APPENDIX H

PROCESS TEAM MEETING/CONFERENCE CALL NOTES

Subject: Project Kick-off Meeting	
Client: South Dakota Department of Transportation	
Project: Watertown South Connector	Project No: 39319
Meeting Date: 6/8/06; 1:30 p.m.	Meeting Location: SDDOT Watertown Area Office
Notes by: ju	Notes to: attendees

Subject: Segment 2A Design Layout Review by Process Team	
Client: South Dakota Department of Transportation	
Project: Watertown South Connector	Project No: 39319
Meeting Date: 01/11/07; 9:00 a.m. to 10:45 a.m.	Meeting Location: Conference call
Notes by: HDR (1/24/07 revisions)	Notes to: attendees

Figure
2-6

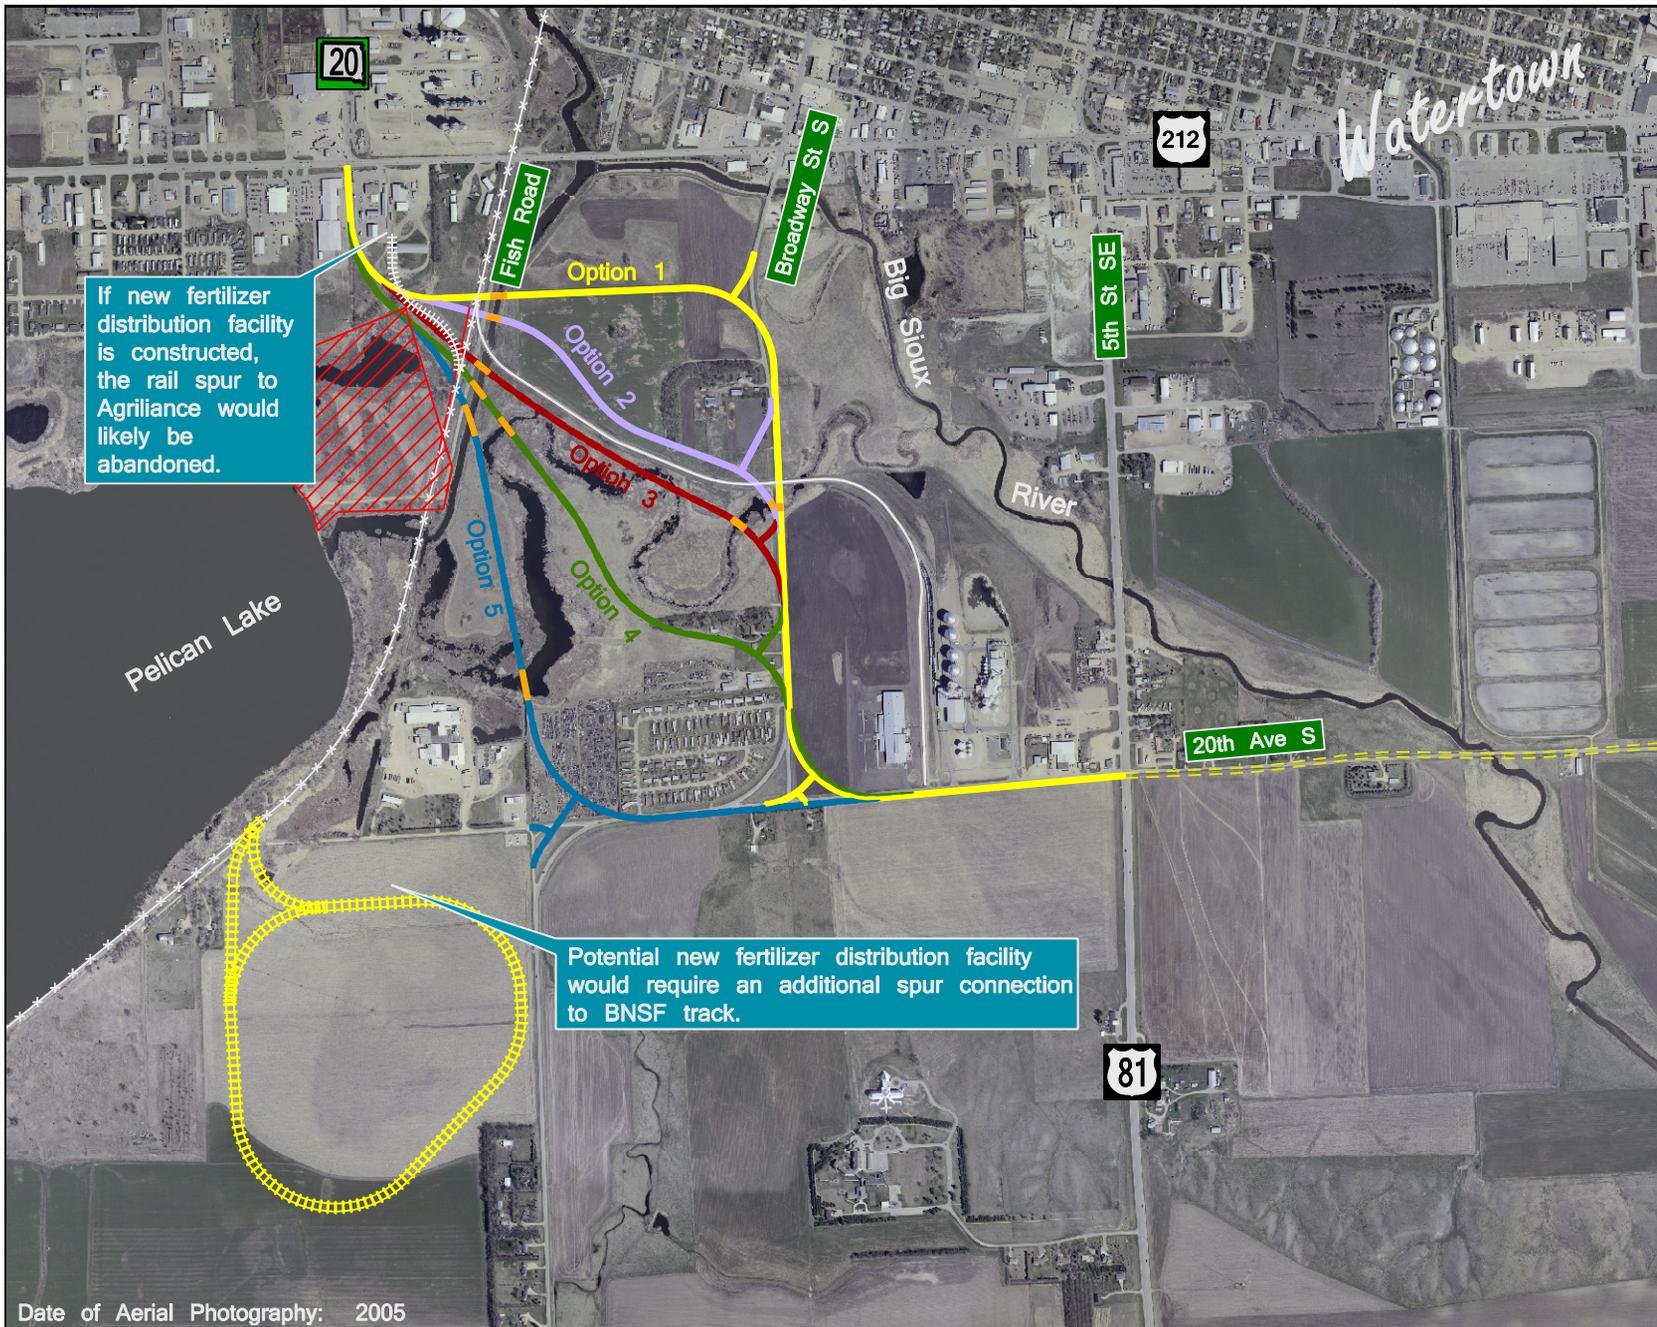
Option 2 (follows along north side of rail spur to ethanol plant)

- The crossing angle of the ethanol plant rail spur is not desirable.
- Train cars from ethanol plant rail spur cross Broadway Avenue multiple times each day and would potentially block traffic on this option for extended periods of time.
- Impacts parcel in northeast quadrant of existing Broadway Avenue/20th Avenue intersection. Focus Watertown views this area as prime industrial development property and does not want the size of the parcel reduced.

Option 3 (follows along south side of rail spur to ethanol plant)

- The crossing angle of BNSF RR tracks is favorable.
- The roadway does not cross the ethanol plant rail spur.
- The roadway parallels the ethanol plant rail spur embankment and therefore would likely not disrupt the hydraulic characteristics of the area.
- No residential property acquisitions.
- Generally fulfills purpose and need of project because it has minimal number of curves.
- Alignment could be shifted slightly to the south to minimize impacts to the electrical transmission line.

- Impacts wetlands (2.6 acres); wetland impacts could likely be mitigated within the City-owned parcel south of the ethanol plant rail spur.
- Has most channel realignment of all options (800 feet).
- Impacts parcel in northeast quadrant of existing Broadway Avenue/20th Avenue intersection. Focus Watertown views this area as prime industrial development property and does not want the size of the parcel to be reduced.

Option 4 (cuts diagonally across open area south of rail spur to ethanol plant)

- The crossing angle of BNSF RR tracks is less favorable than options 2, 3, or 6.
- Less desirable for fulfilling purpose and need of project (truck bypass of US212) because it has multiple curves.
- Impacts wetlands (2.3 acres); wetland impacts could likely be mitigated within the City-owned parcel south of the ethanol plant rail spur.
- Three (3) residential property acquisitions.
- Impacts parcel in northeast quadrant of existing Broadway Avenue/20th Avenue intersection. Focus Watertown views this area as prime industrial development property and does not want the size of the parcel to be reduced.

- The crossing angle of BNSF RR tracks is the least favorable of all options.
- Impacts wetlands (3.1 acres); wetland impacts could likely be mitigated within the City-owned parcel south of the ethanol plant rail spur.
- Two (2) residential property acquisitions.
- Approximately 600 feet of channel realignment necessary.
- Costs approximately \$1 million more than options 1, 2, 3, or 4.
- Impacts one (1) salvage yard.

- Option 1 **is not preferred** because it crosses the Big Sioux River floodway.
- Option 2 **is not preferred** because it crosses the rail spur to the ethanol plant.
- Option 3 **is preferred** because:
 - It requires no residential property acquisitions,
 - There are fewer curves in the alignment than most of the other options, thus more completely fulfilling the project “purpose and need” aspect of diverting truck traffic from US 212.
- Option 4 **is not preferred** because:
 - It requires 3 residential property acquisitions,
 - To avoid impacts to the drainage channel and to the mobile home park, the alignment contains several relatively sharp reverse curves.

- **Option 5 is not preferred** because:
 - It crosses one existing salvage yard,
 - It requires 2 residential property acquisitions,
 - Cost is 10% to 20% higher than other options,
 - Potential contaminated soils in salvage yards could add significant expense and delay the project.
- **Option 6 is not preferred** because:
 - It crosses 2 existing salvage yards,
 - It requires 2 residential property acquisitions,
 - Cost is 10% to 20% higher than other options,
 - Potential contaminated soils in salvage yards could add significant expense and delay the project.
